# Engineering Change Notification

Product Change of NPT/INCH Fittings QSK (L)

**Project No**  
238 175

**Project Title**  
QS NPT/INCH Fittings

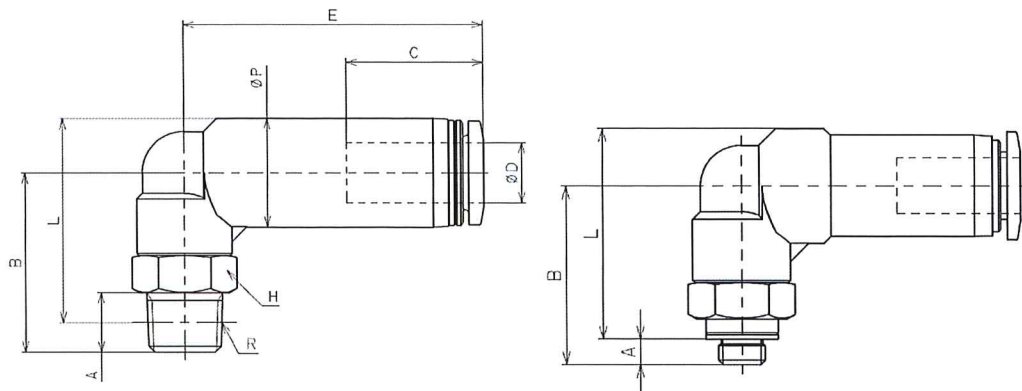
Realisation of a uniform product design for the complete QS Fitting series

The design modification is following to the already completed change of metric fittings (for QS and QS-VO).

There are different dimension for the housing and length of thread connector (optimized on small/compact dimension) for these fittings.

The product change has no impact on the technical data.
